SUNDRY NOTICES AND REPORTS ON WELLS
Do not use this form for proposals to drill or to re-enter an abandoned well. Use form 3160-3 (APD) for such proposals.

PLUG AND ABANDONMENT PROCEDURE

Gallegos Canyon Unit #597

CONDITIONS OF APPROVAL

Proposed P&A

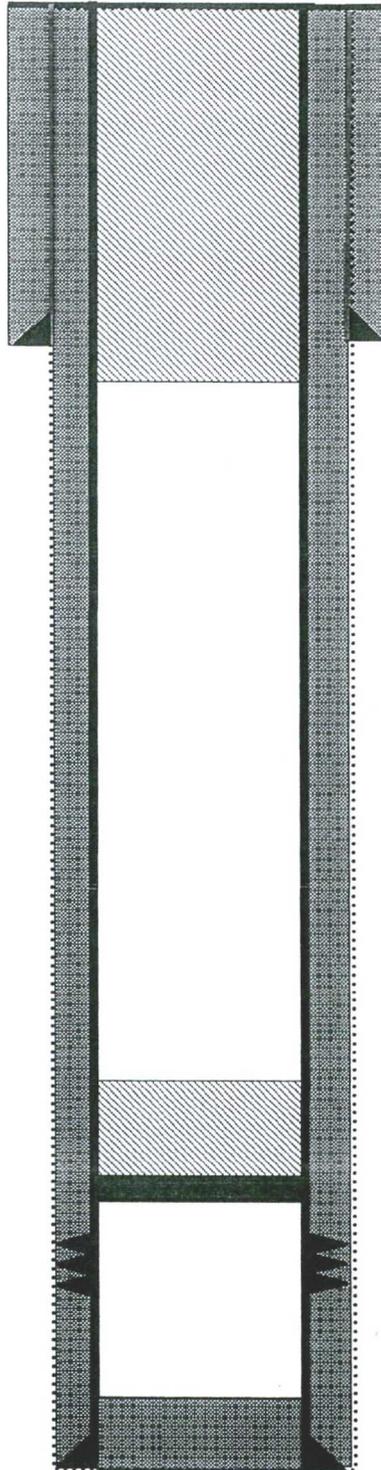
1. Plugging operations authorized are subject to the attached "General Requirements for Permanent Abandonment of Wells on Federal and Indian Lease."
2. Farmington Office is to be notified at least 24 hours before the plugging operations commence (505) 564-7750.
3. The following modifications to your plugging program are to be made:
 - a) Set plug 1 (1440 - 1135) ft. to cover the Fruitland top. BLM picks top of Fruitland at 1185 ft.

You are also required to place cement excesses per 4.2 and 4.4 of the attached General Requirements.
